ADDENDUM NO: 1

PROJECT: **SITE IMPROVEMENTS AT FRANKLIN CENTRAL JUNIOR HIGH**

CONTEXT PROJECT NO: 22-1613 DATE: 2/13/2024 BY: Fred Prazeau

Sheet No: C301

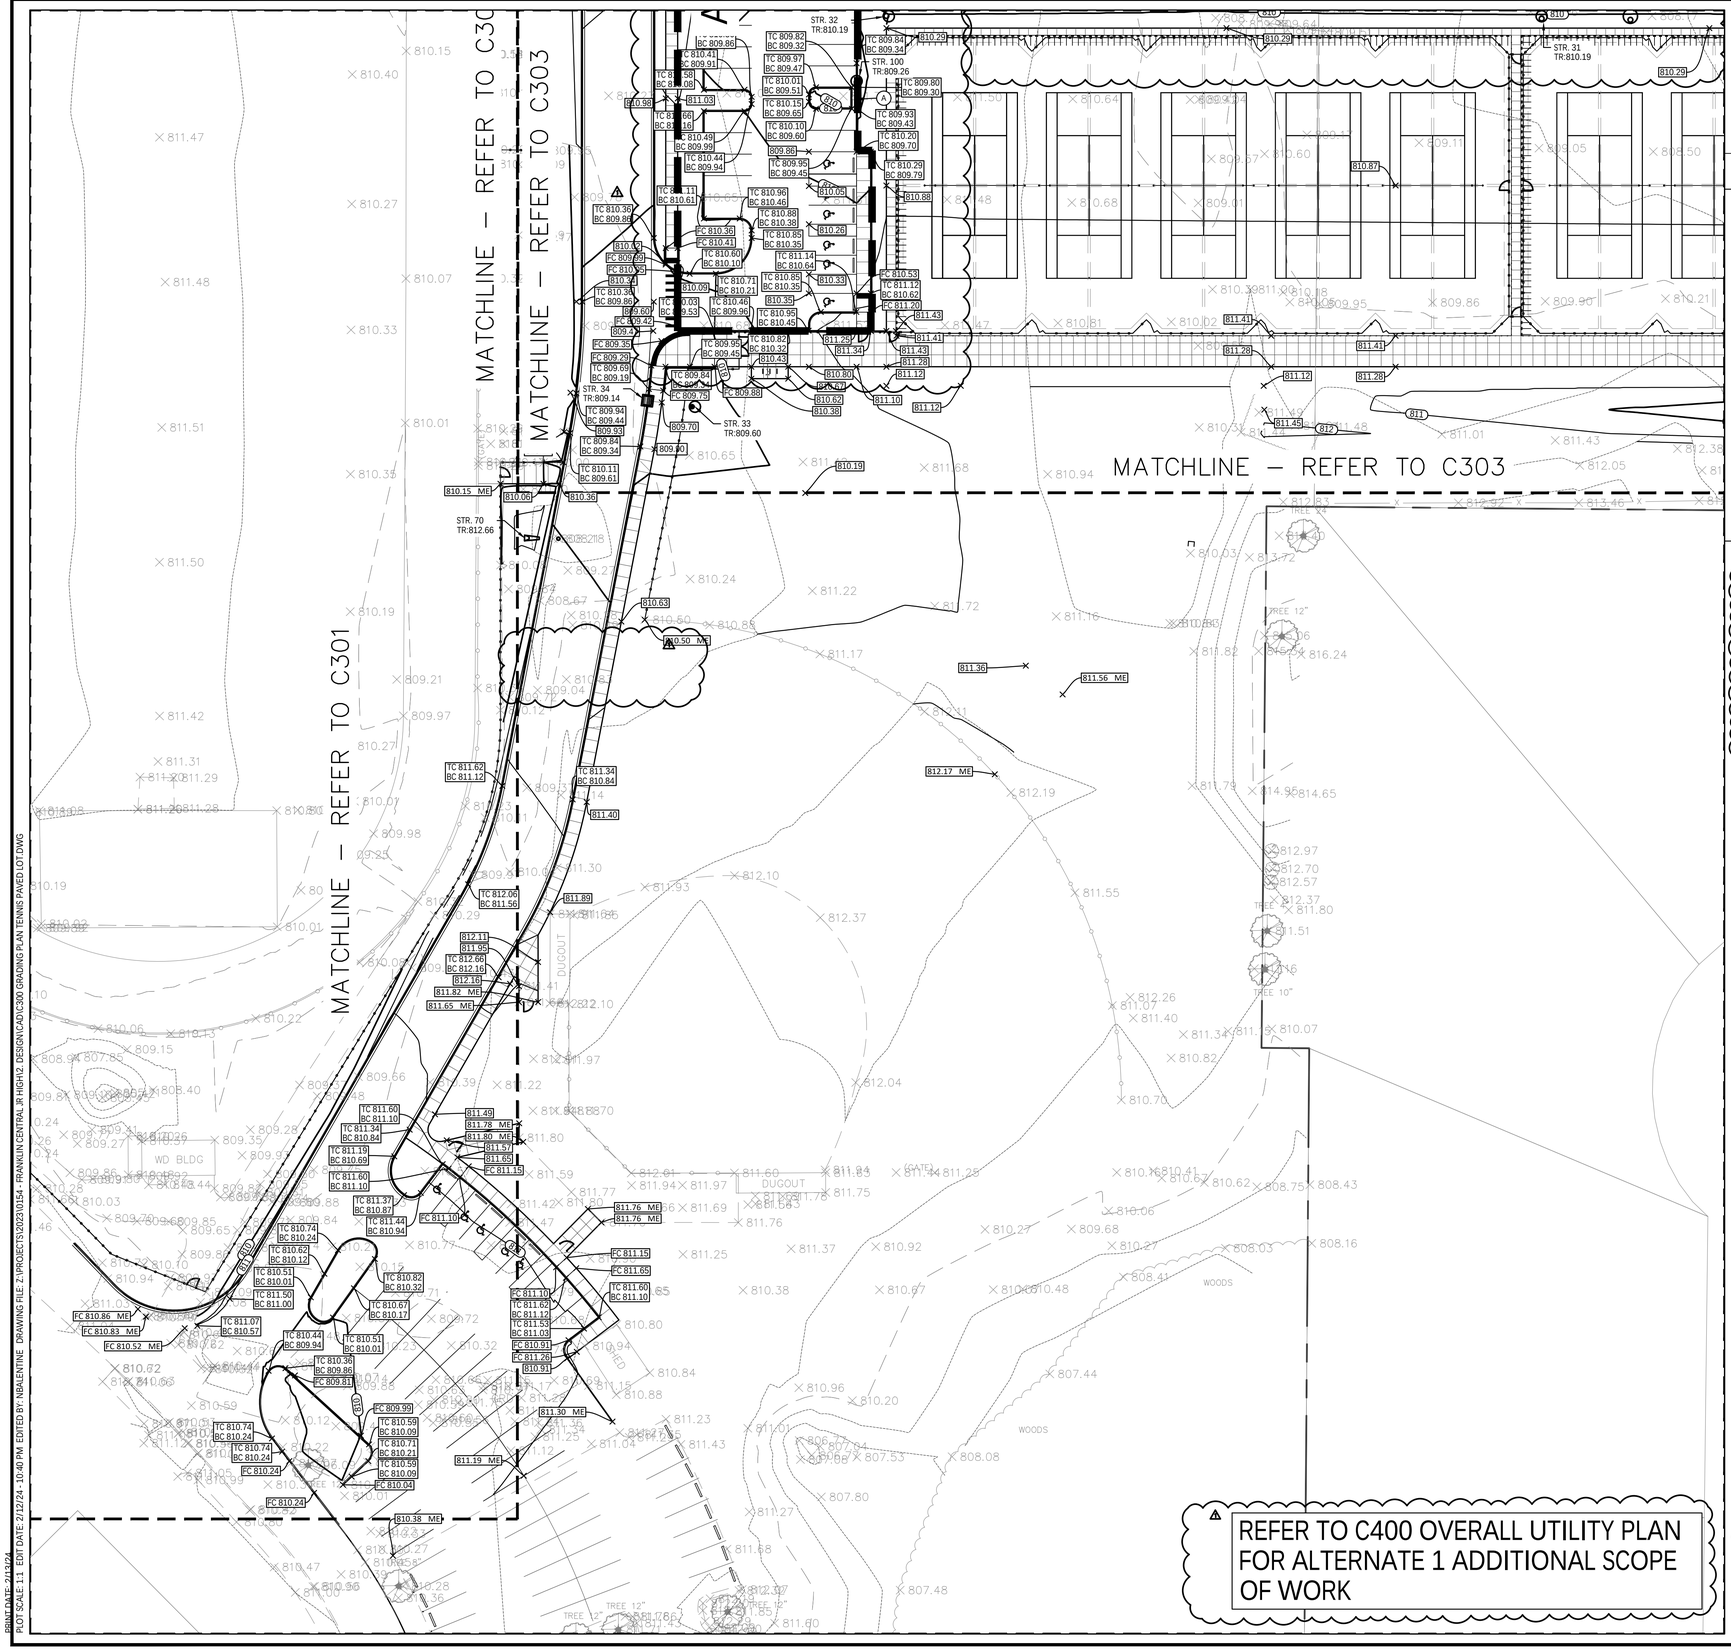
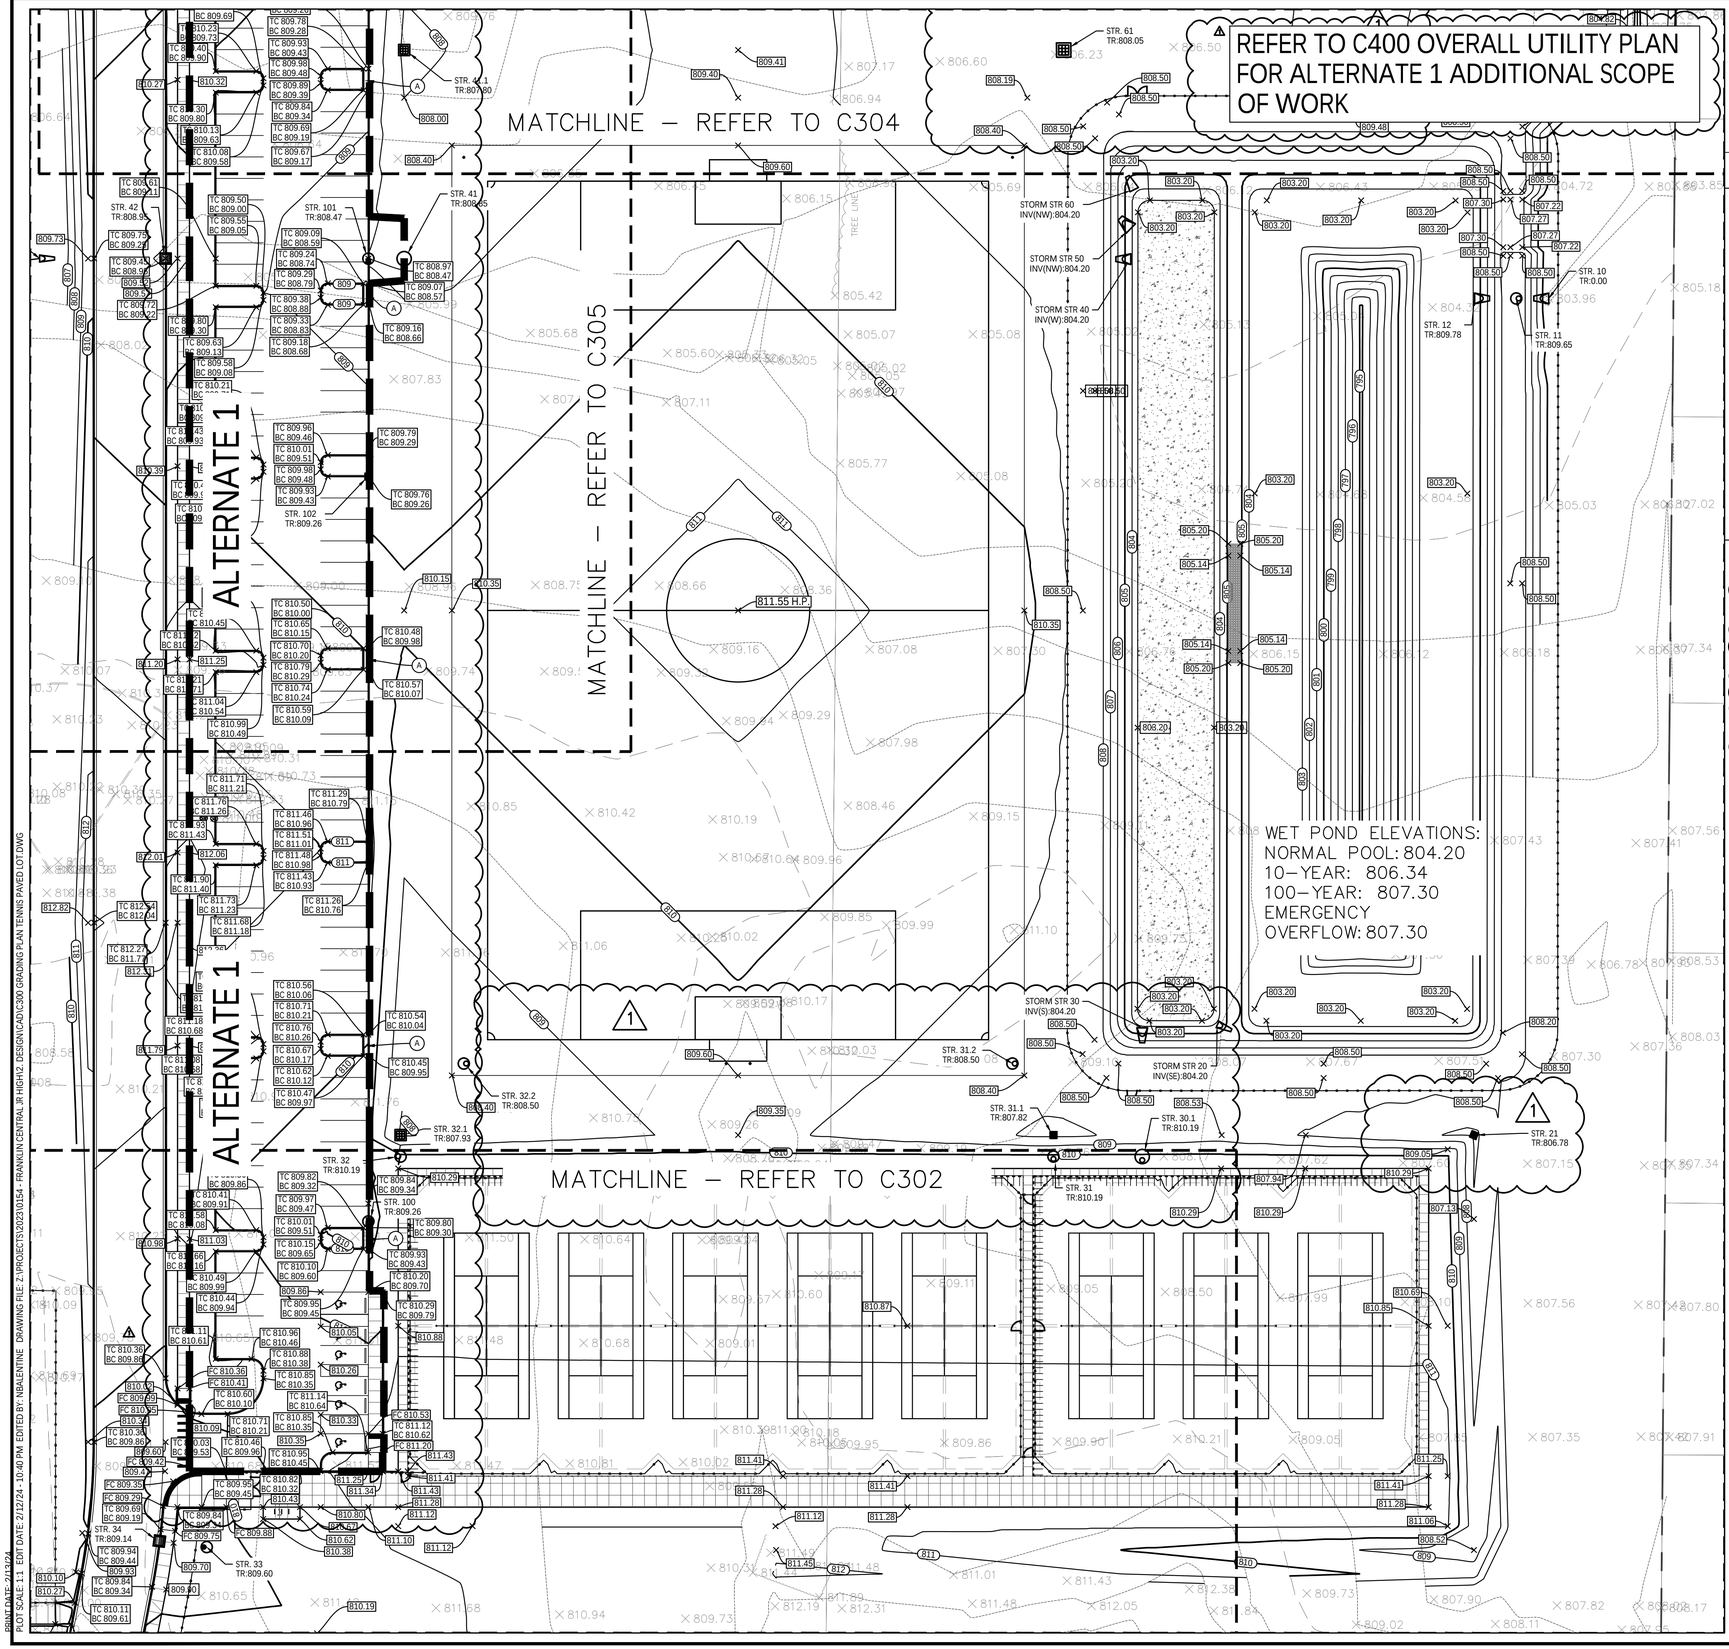
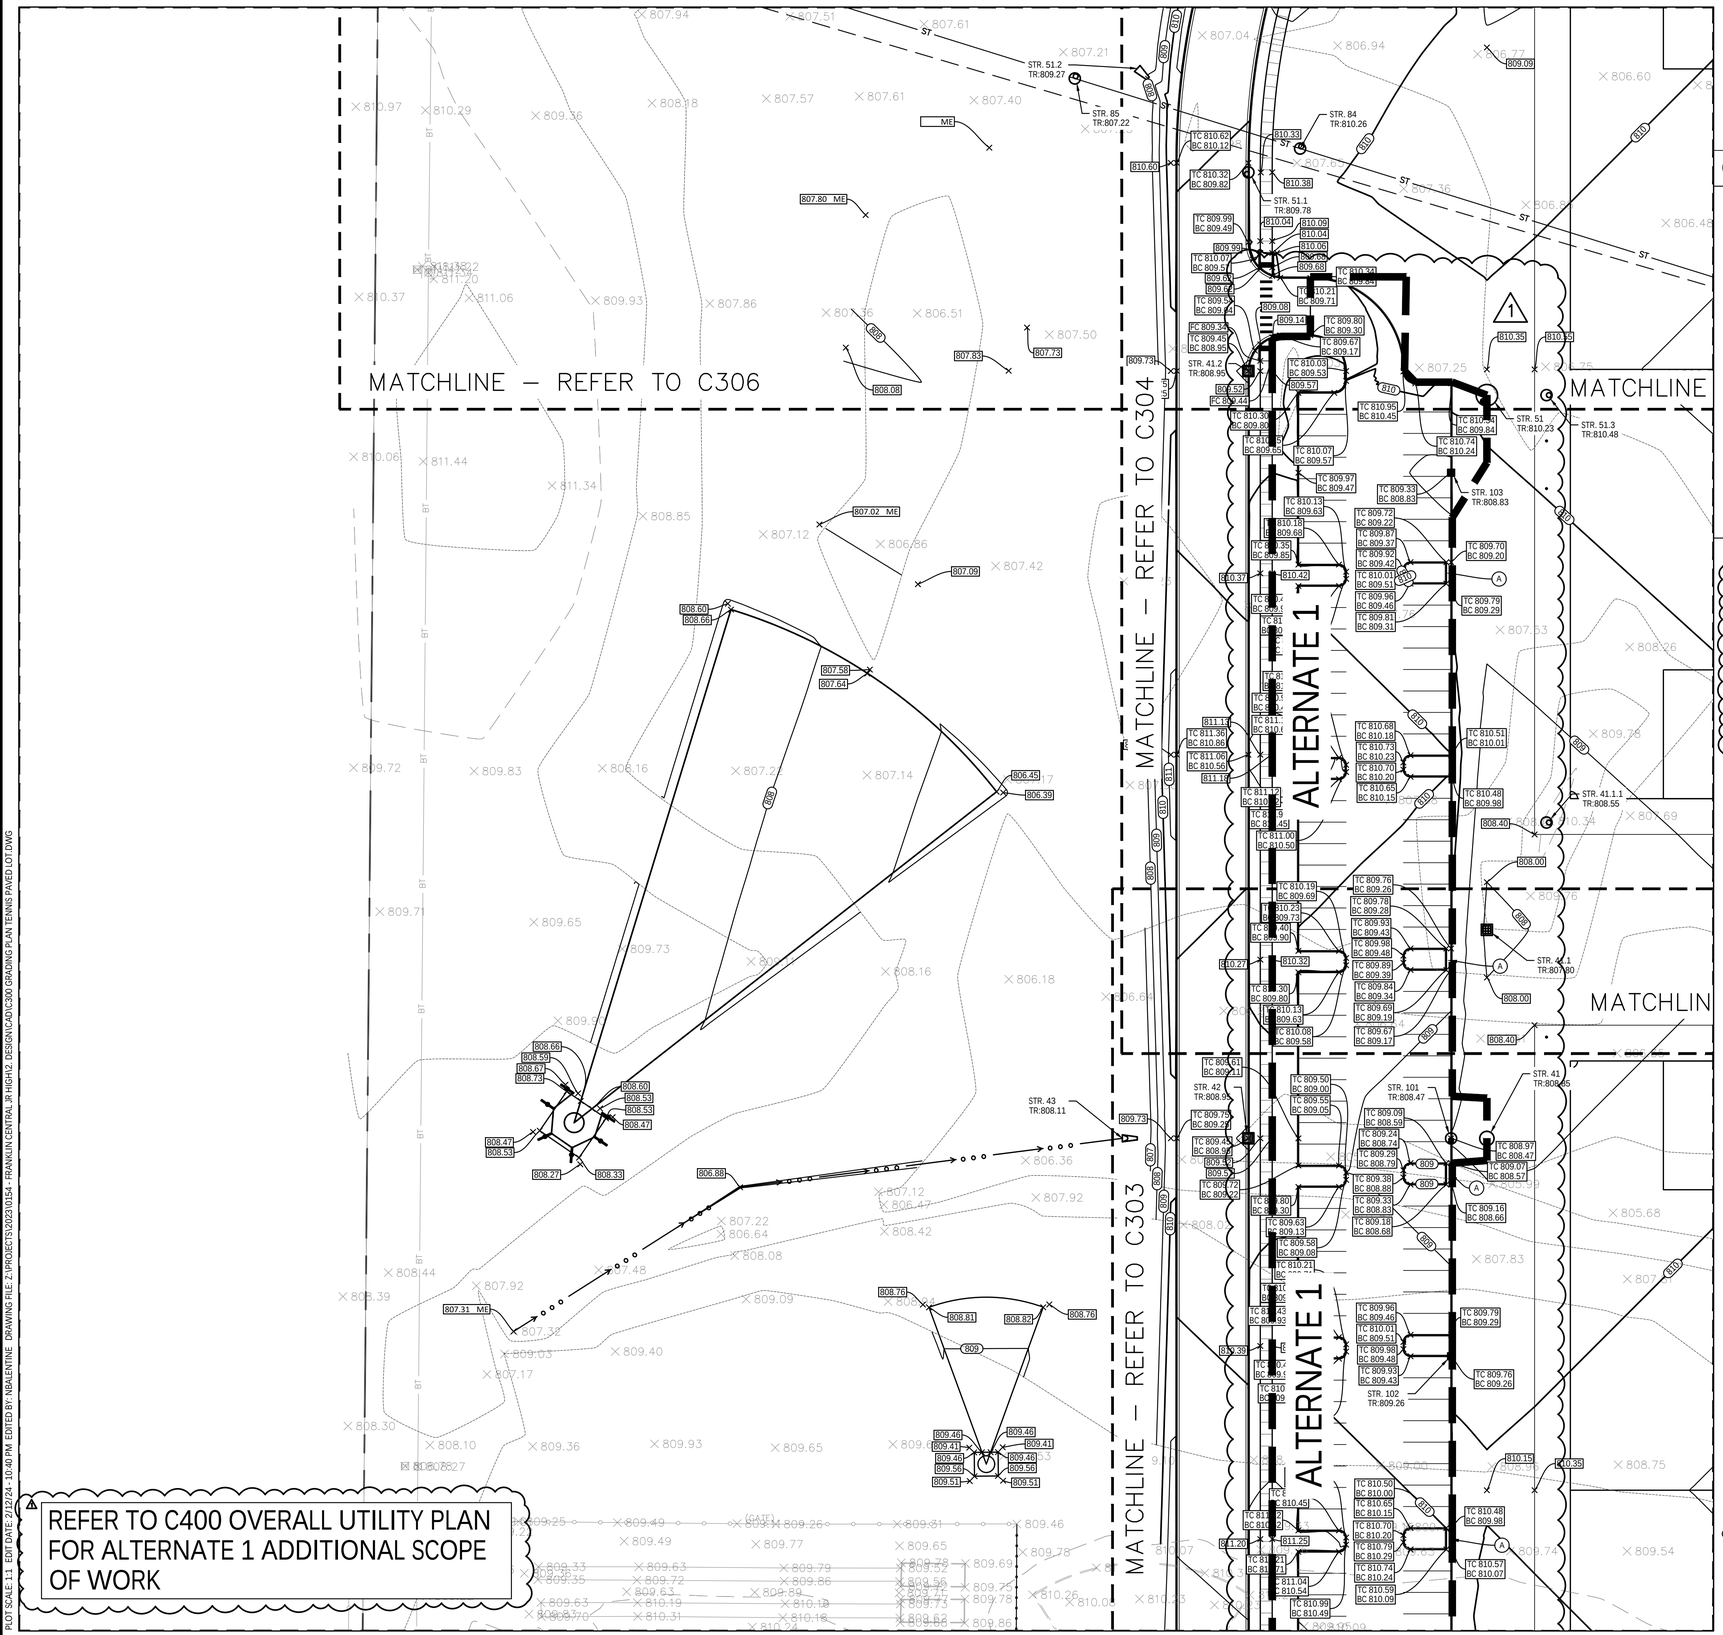
2. C300-Series Grading Plans reissued to address City comments, including clarification along drainage swales and grading in the vicinity of Alternate #1 – Soccer Parking.
